Pearmtree Hill Solar Farm

Environmental Statement

Figure 14.4: Link Sensitivity

Revision 2

Environmental Statement Volume 3, Figure 14.4: Link Sensitivity

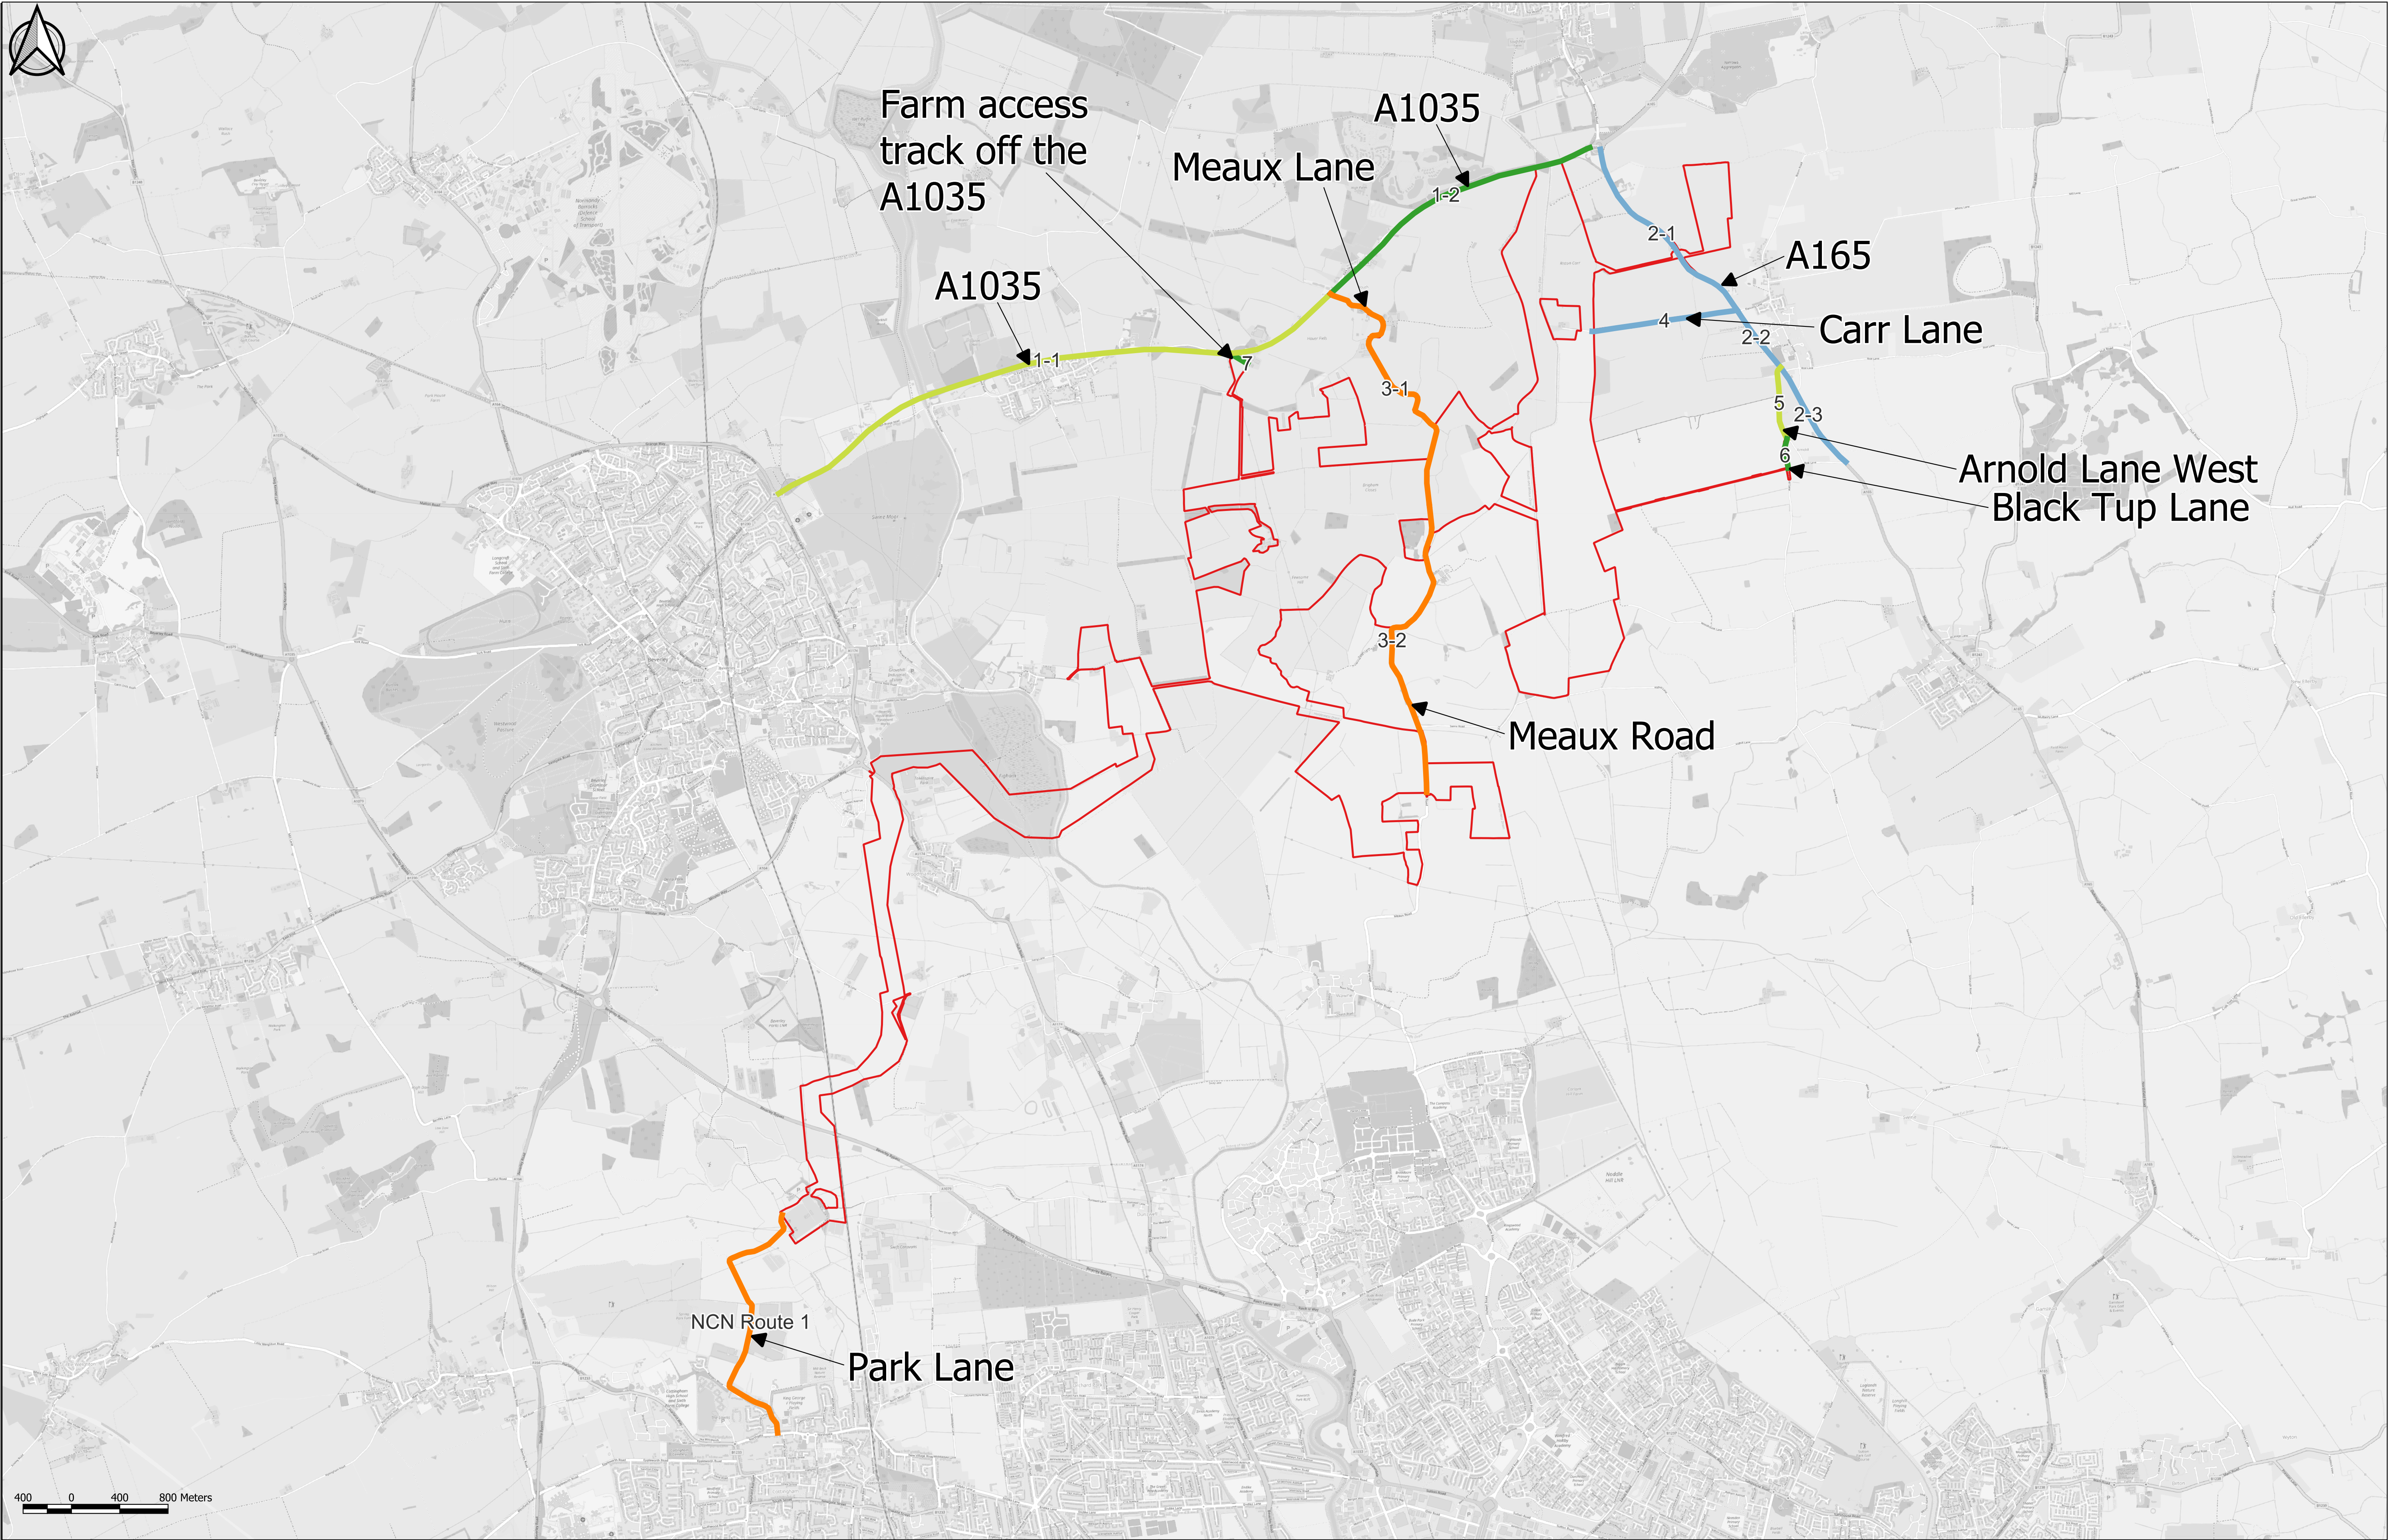
1. Figure 14-4 Revision P02 incorporates the following changes; the addition of the farm access track off the A1035 (Change 9).
